Three Mile Island Nuclear Station Unit No. 1
Docket Number 50-289

Errata Sheet to responses to questions raised in Enclosure 2
of the NRC's 2-18-76 letter to TMI-1 concerning Appendix I

RESPONSES TO QUESTIONS RAISED IN ENCLOSURE 2

CONCERNING APPENDIX I

FIGURE 8-14

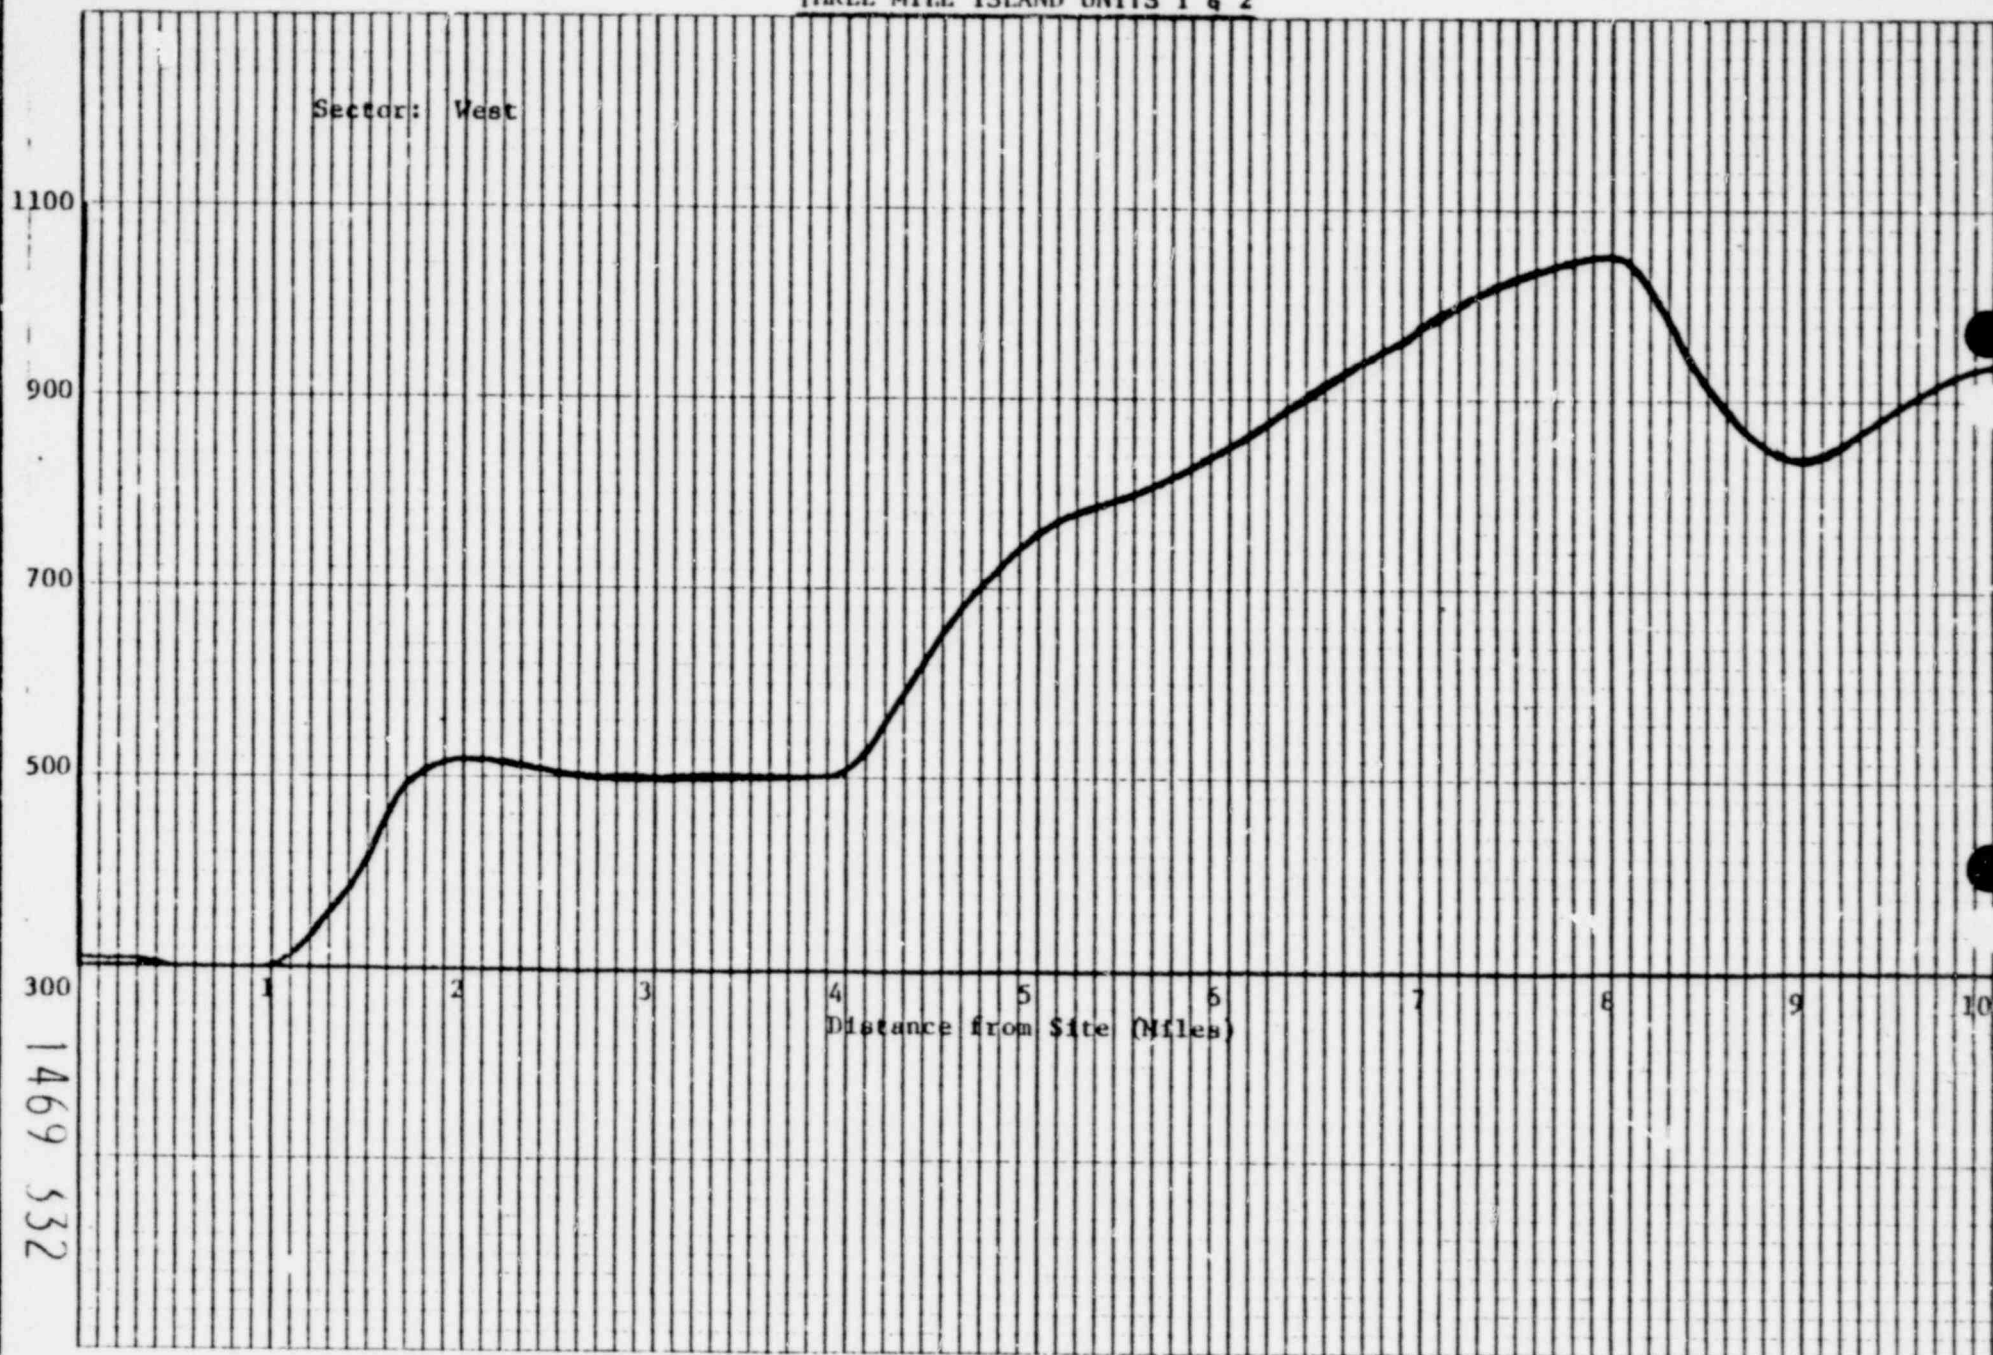
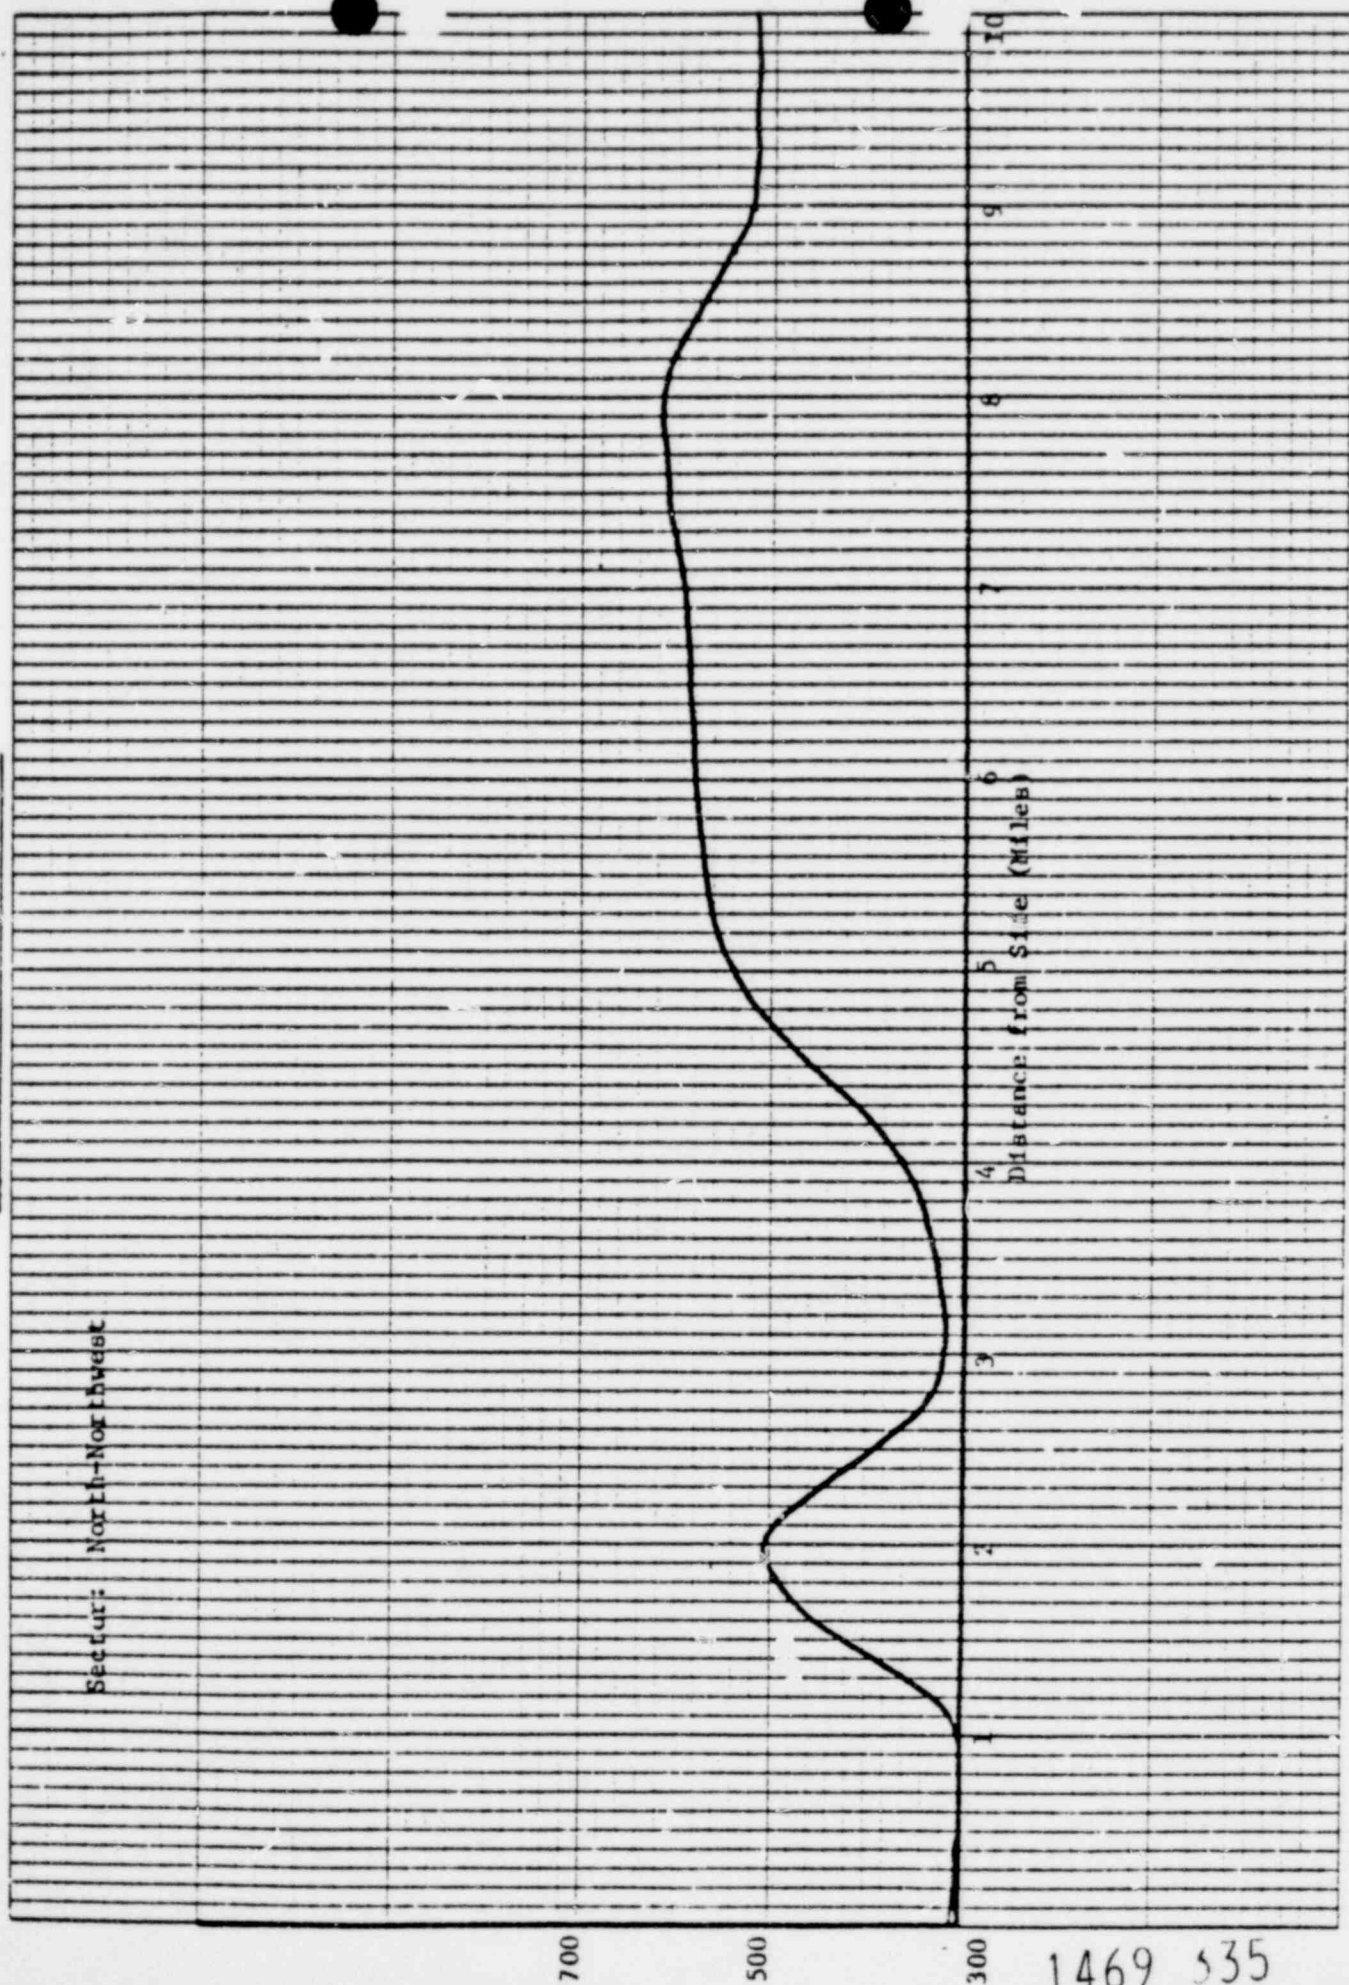
Provide a map showing the detailed topographical features (as modified by the plant) on a large scale, within a 10-mile radius of the plant and a plot of the maximum topographic elevation versus distance from the center of the plant in each of the sixteen 22-1/2 degree cardinal compass point sectors (centered on true north), radiating from the center of the plant, to a distance of 10 miles.

RESPONSE

See attached Table 8-1 and Figures 8-1 through 8-16.
